**VILLAGE OF LAKE BLUFF  
ARCHITECTURAL BOARD OF REVIEW**

**SUBJECT:** **Agenda Item #6 -- A Public Hearing to Consider a Site Plan to Review Exterior Alterations to the Central Lake County Joint Action Water Agency Building at 200 Rockland Road**

August 28, 2016

The Central Lake County Joint Action Water Agency (CLCJAWA) is requesting an appearance before the Lake Bluff Architectural Board of Review (ABR) to consider two items.

**1. Noise Barrier Sound Remediation for Existing Equipment**

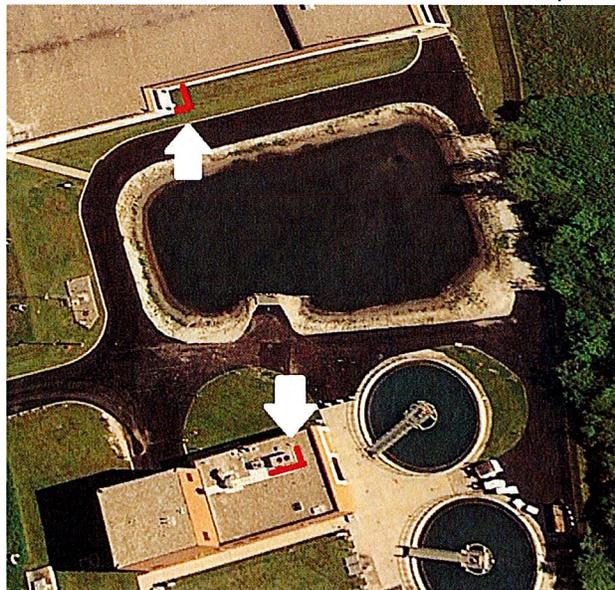
*Backwash Blower Room Inlets/Outlet*

This area is located on the south side of the main building. It would be wrapped with a 17' long by 9' wide by 11' tall sound wall that also contains a double door for access. It is shown at the top of the image in red.

*Roof Top Chiller*

The chiller unit on the roof of our Residual Solids Processing Building requires a sound barrier wall. The proposed wall would wrap around the east and south

sides of the unit and would be perforated inside to absorb sound. The wall would be approximately 20 feet long by 12 feet wide by 8 feet tall. An approximate depiction of the wall is shown at the bottom of the image in red.

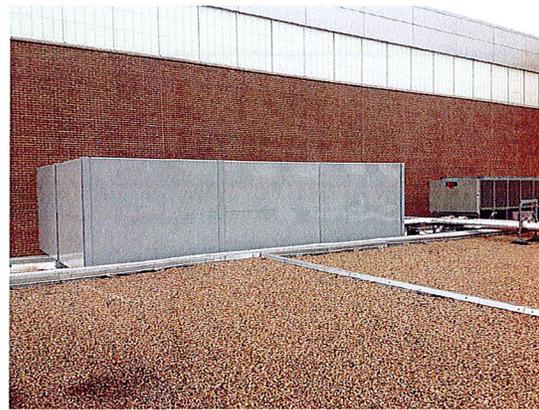
Both sound walls will be composed of painted steel and will be perforated inside to absorb sound. CLCJAWA would prefer to use a color similar to that shown in the picture on the right.

### *East and South Elevations*

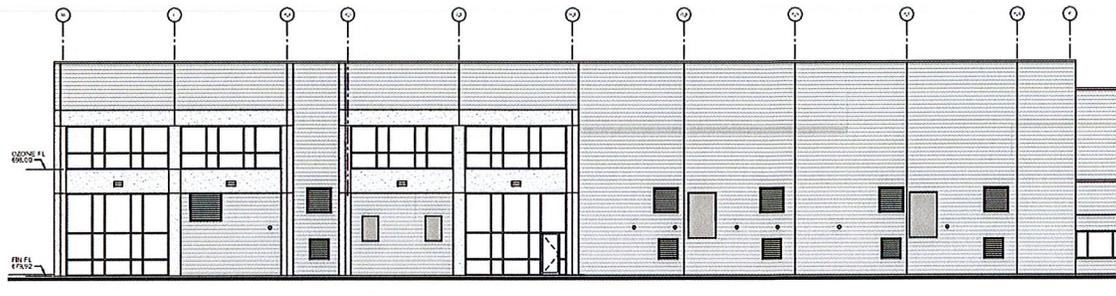
The number of previously approved louvers has been reduced in order to direct the sound that would have spilled from them, through the roof and towards the sky. Other louvers will be shielded with acoustical hoods that will extend from the wall and direct sound downwards towards the ground. The pictures on this page show the existing louvers. The top photo is of the building's east elevation. The bottom photo is the building's south elevation.

**E EAST ELEVATION**  
SCALE: 1/8"=1'-0"  
FILE: 30841304403

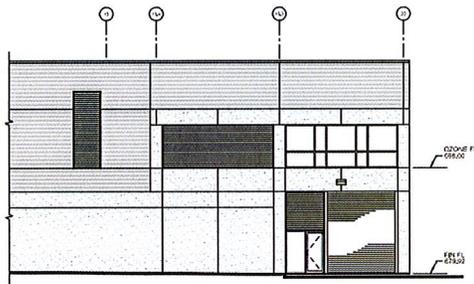
The next page depicts the proposed louvers and hoods on a drawing. The hoods are shown as dark rectangles. They will be colored to match existing building details. Their size is dictated by the required air inlet or exhaust for each piece of equipment or area that they serve.

The two hoods on the right of the drawing will be 66 inches wide, 87 inches tall and will extend 57 inches from the wall. The two hoods on the left of the drawing are 44 inches wide, 65 inches tall and will extend 35 inches from the wall.

### Roof Fans

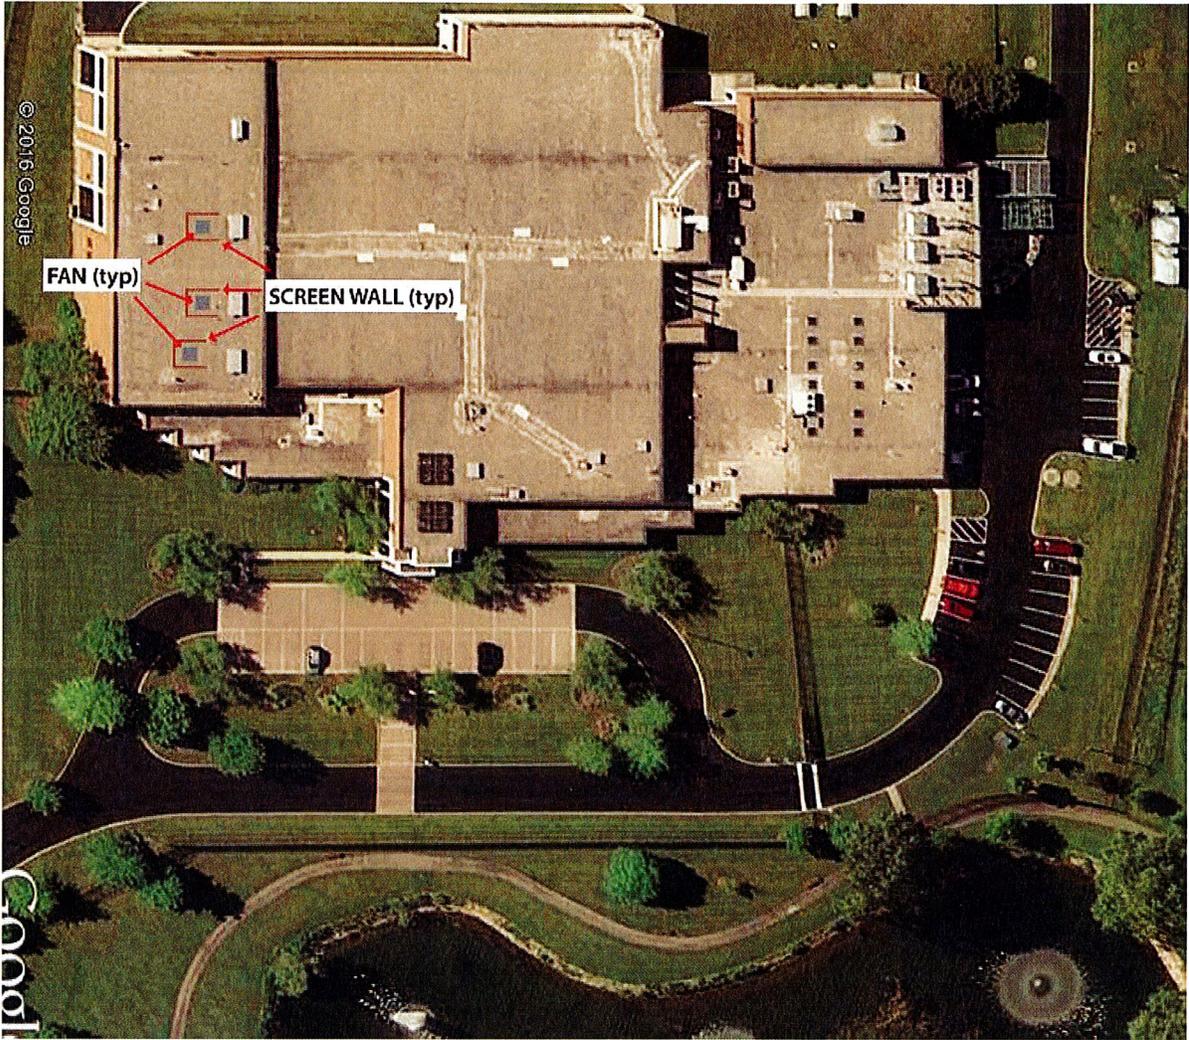
Fans that previously vented out of the east elevation will be relocated to the roof. It is the desire of CLCJAWA not to provide a visual barrier for these fans because of the numerous additional roof penetrations that will be required, maintenance, wind load concerns, appearance and cost. This fans can be ordered with a powder coating. Based on previous ABR preferences, we would recommend concrete gray or similar color.

In order to assess the appearance of these fans alone or the fans obstructed with a screen wall, the following images are presented. The first image depicts an aerial view of the water treatment facility and the location of the needed fans (and visual barriers if required by the ABR). The bottom of the picture faces north.

Two roof mounted fans will be approximately 6.5 feet wide, 6.5 feet long and 4 feet tall. The third will be 7.5 feet wide, 7.5 feet long and 4 feet tall.

Each vision barrier wall would be approximately 5 feet tall, 17 feet long and will be located on the east, north, and south sides of each fan. The size of the screen walls is larger than the equipment to allow maintenance access. If required by the ABR, the color would be as requested by the ABR.
